**Maywood Chemical Company Superfund Site**

**Operable Unit 2 - Groundwater**

# Final Groundwater Record of Decision

May 2012

**FIGURE 6**  
**BENZENE GROUNDWATER PLUME**  
 MAYWOOD SUPERFUND SITE, NEW JERSEY

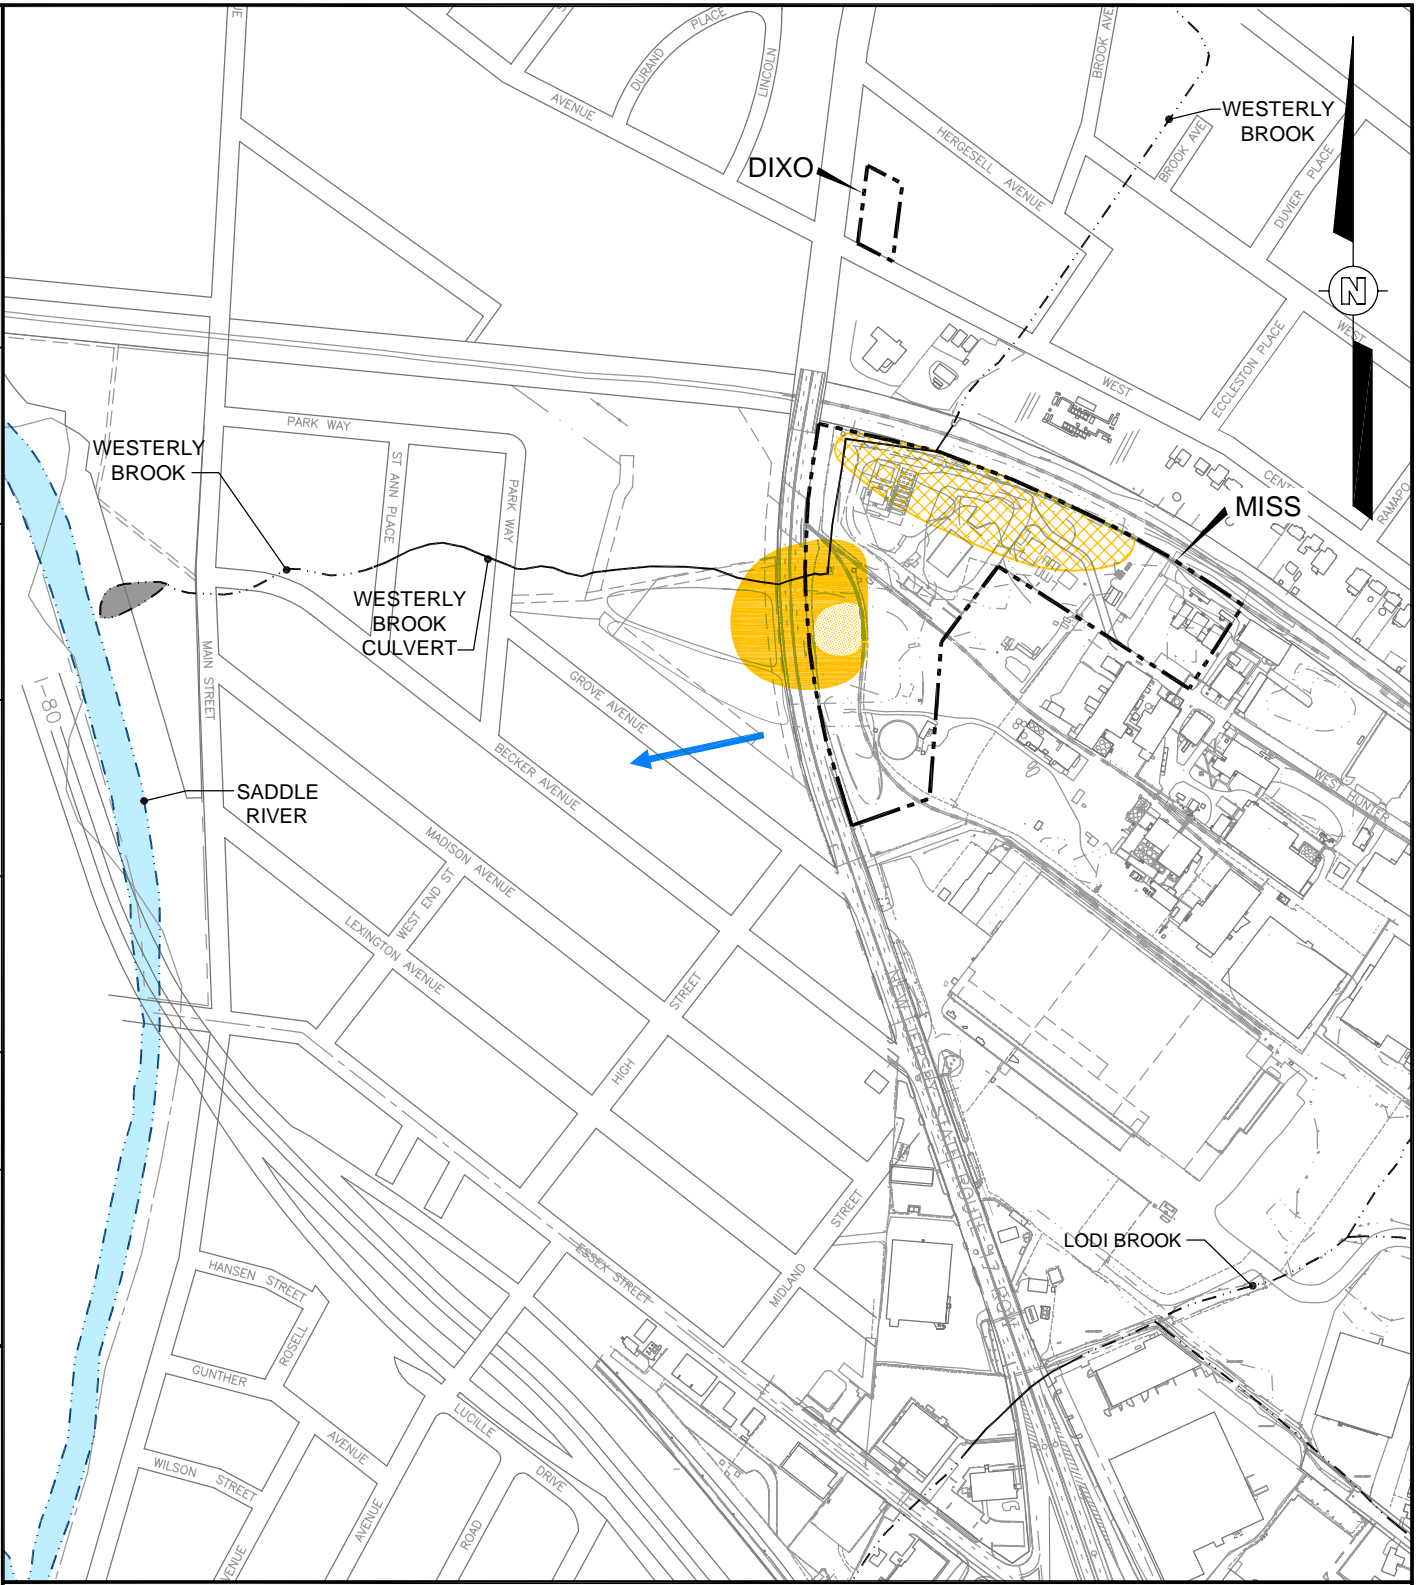
The NJDEP noted that vapor intrusion could potentially exist at the southwest corner of the site, approximately 150 feet north of the Grove Avenue and Route 17 intersection. At this location, the benzene plume is inferred to have migrated off-site as represented by the 1 µg/L isopleths shown on Figure 1-9 of the Final Groundwater Feasibility Study. The selection of Remedial Alternative 3 as the preferred alternative should be amended to include the evaluation of vapor intrusion issues.

Figure 2  
FMSS and Surrounding Properties

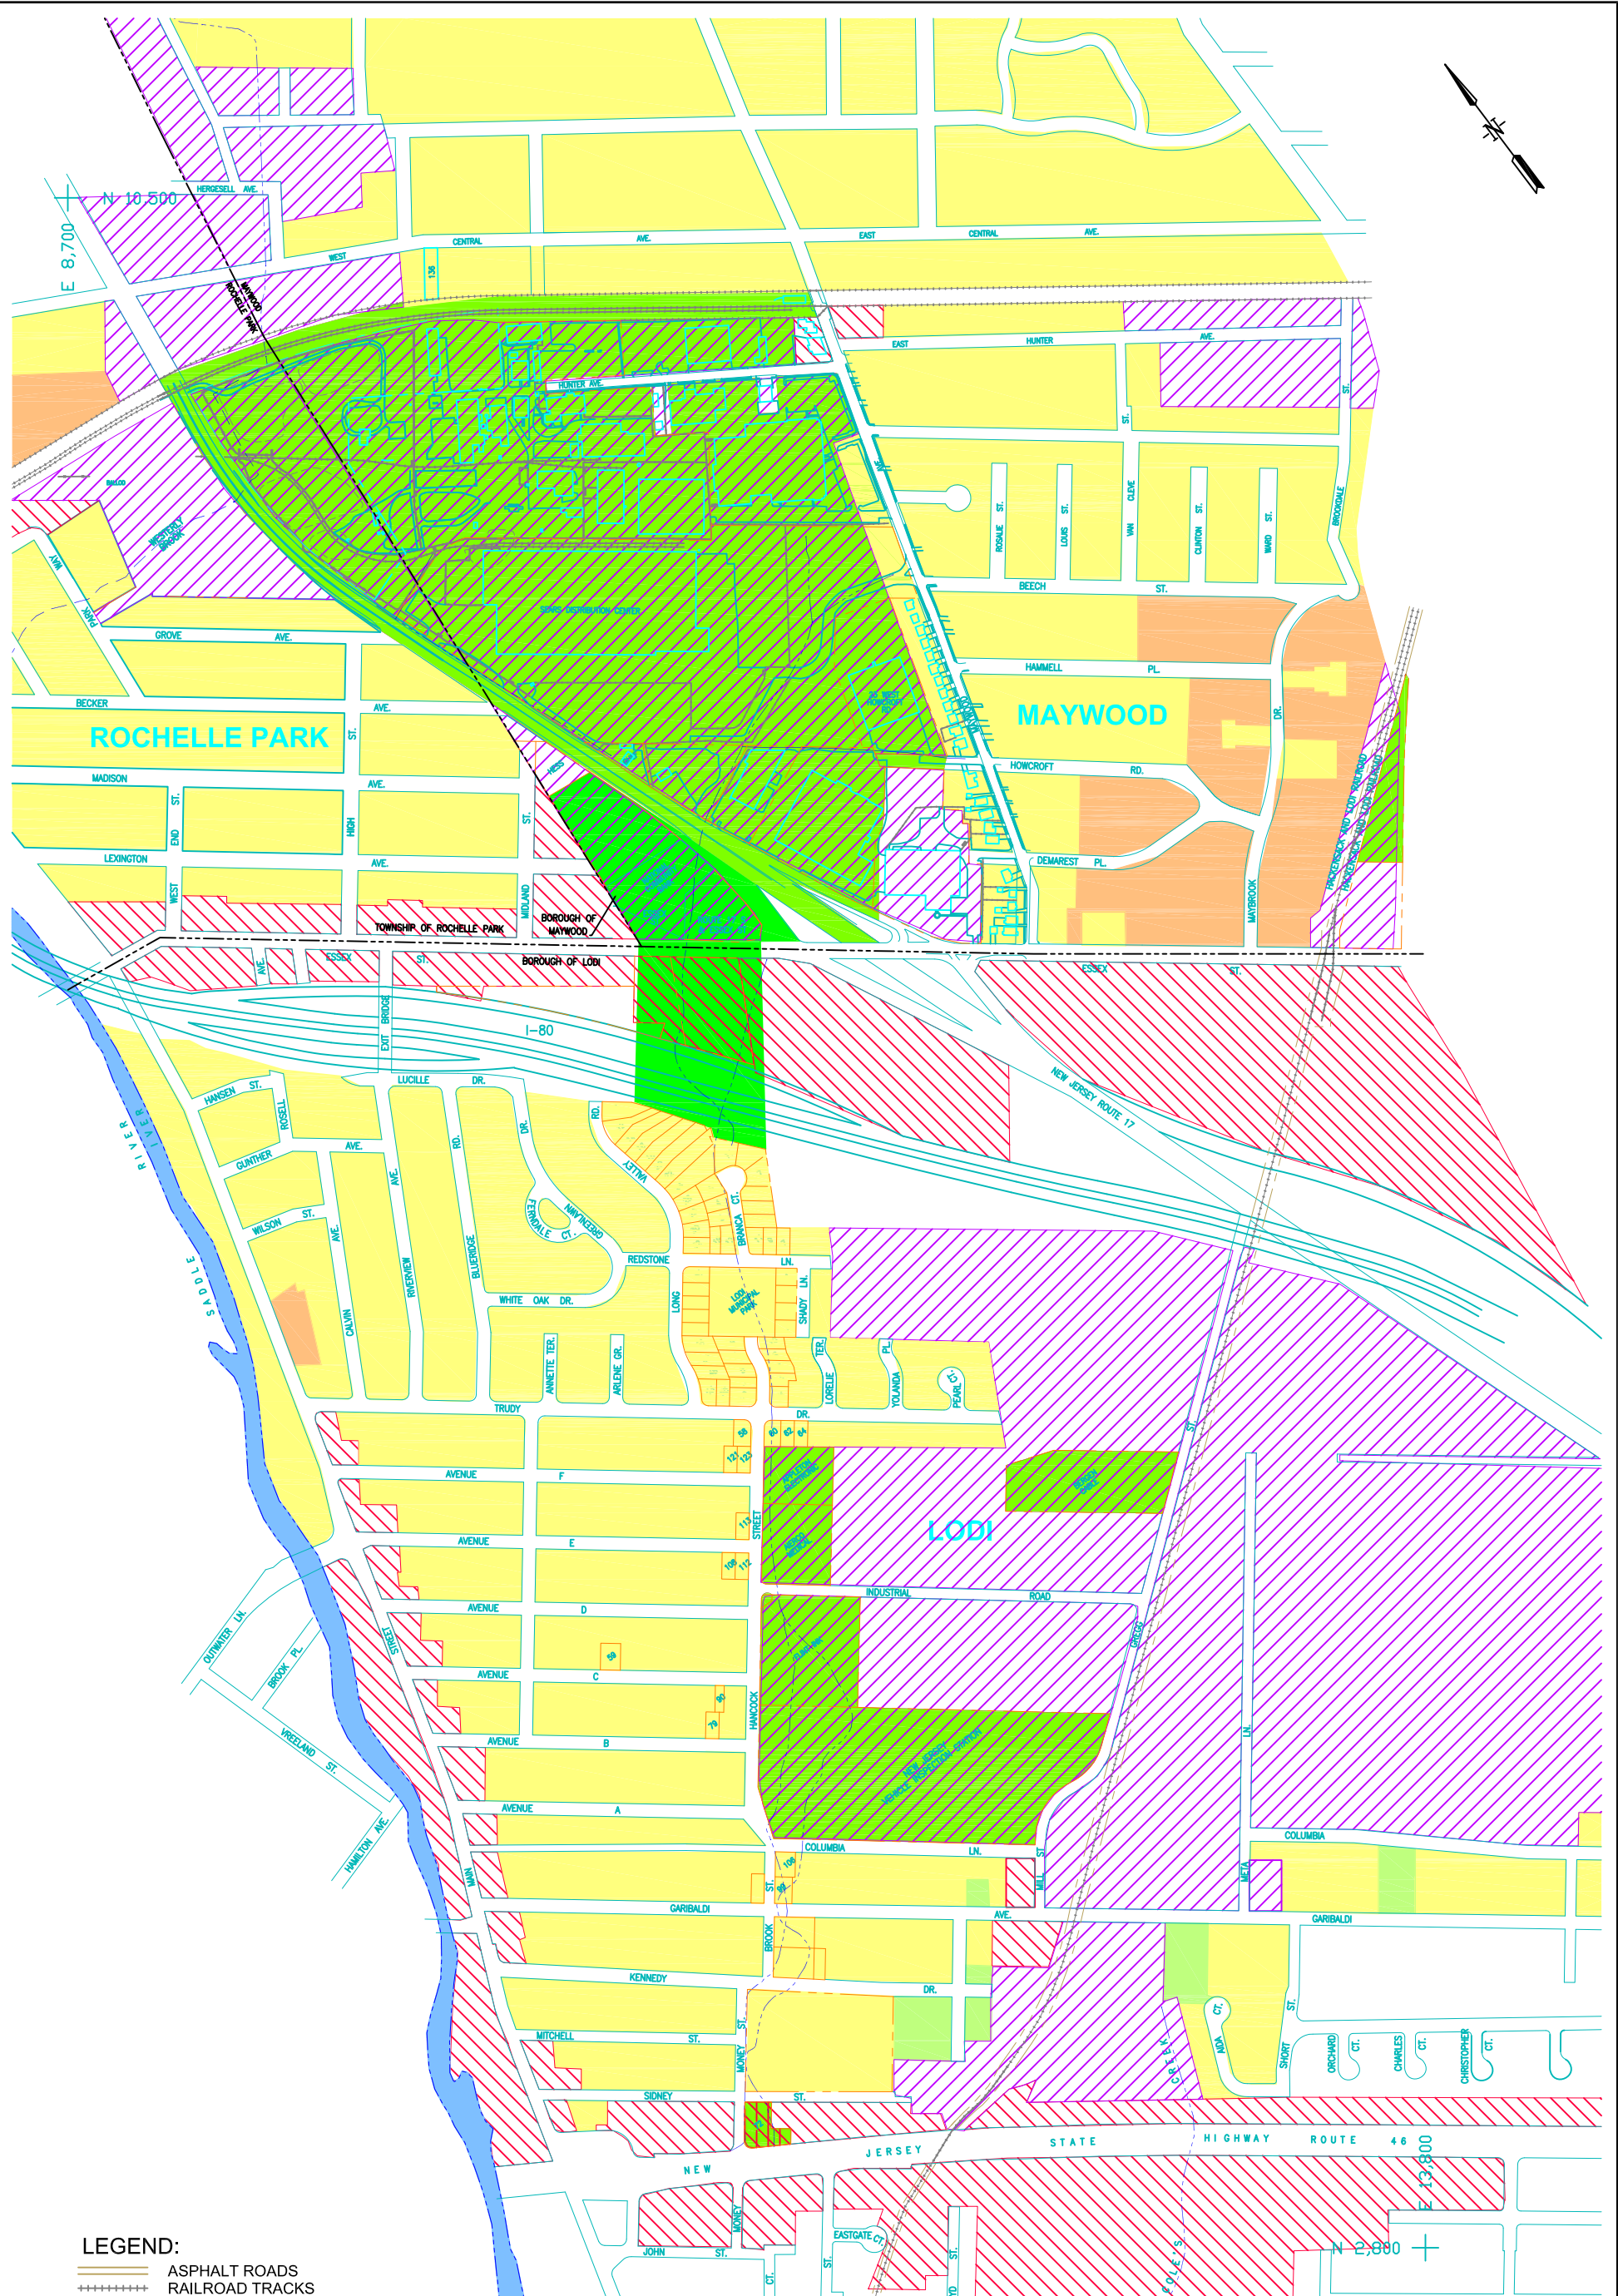
Figure 1-1 of the Groundwater Proposed Plan for Formerly Utilized Sites Remedial Action Program (FUSRAP), Maywood Superfund Site, dated September 2010, does not depict 150, 162, and 174 Essex Street as having been remediated. However, correspondence received and based on conversations with William Kollar of Shaw Environmental, it has been remediated. Figure 1-1 should be revised to reflect the fact that the remediation is complete.

The Bank of New York Mellon properties at 150, 160-162, and 174 Essex Street, Lodi, NJ have been remediated under FUSRAP. The FUSRAP status of your properties is accurately presented in the property-specific Post Removal Action Reports transmitted to BNY Mellon in July 2008. Figure 2 of the Maywood Groundwater ROD (corresponding to Figure 1-1 of the Proposed Plan) has been revised to indicate the completed remediation of properties.
